# 중앙 원형 팝업 수정안 / 전체 조립

예비 수정안 / 구매 팝업 규격 미선정 / 실측 및 시험 전 제작 확정 금지

# 01_Frame_With_Integral_Round_Pad

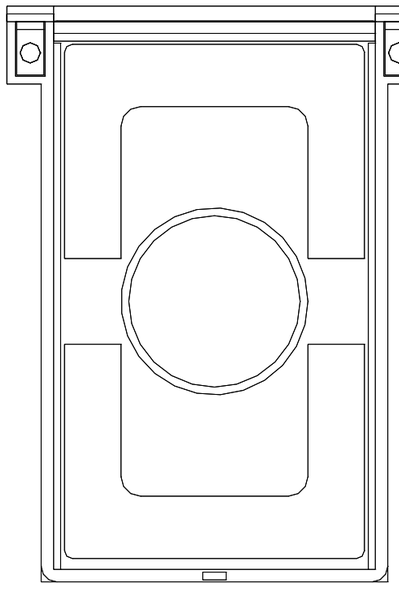
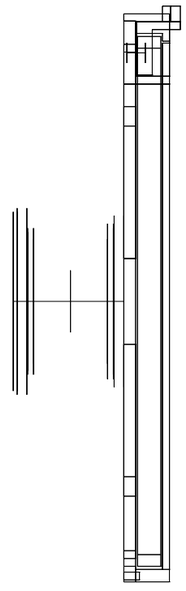
Integral frame mounting pad D44 x2.5

Phone adhesive base D48 x2.5

Purchased popup: upper D40 / lower D38 ASSUMED

Cap separation closed6 / open22 ASSUMED

Upper/lower mounting film0.2 each ASSUMED

Phone - case adhesive1.0 ASSUMED

Folded 26.9 / open 42.9 mm incl. gate

Old link arms, hinge pins, index pins REMOVED

Magnetic gate and mechanical shoulders retained

Popup is a purchased - part ENVELOPE, not a printed spring

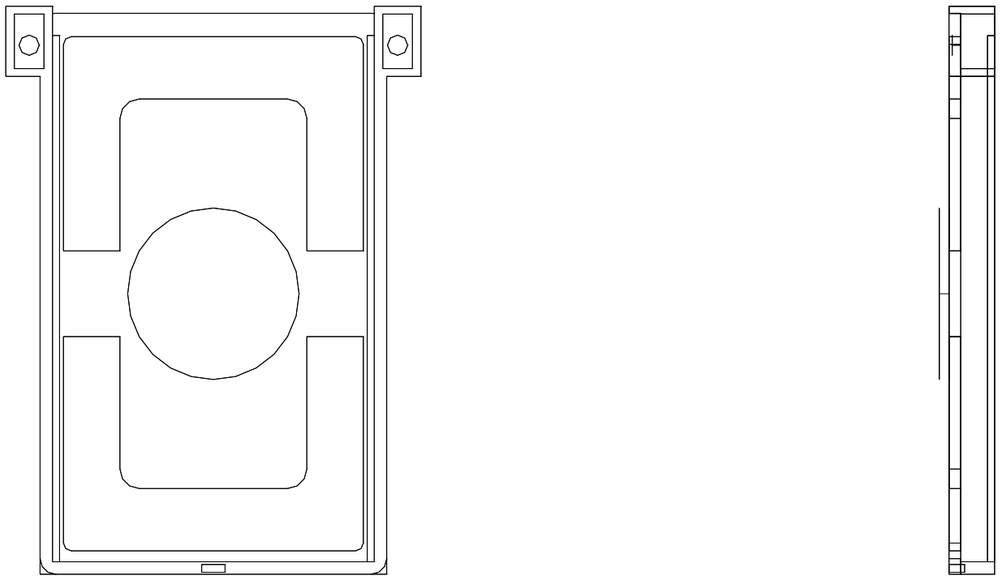
Part01 integral rear pad D44, Z - 2.5..0

Obsolete four M3 mount holes filled; NO link bracket

No printed OEM bellows STL in this release

Vendor - approved attachment to new printed surfaces only

No glue on the original slab or aluminum holder
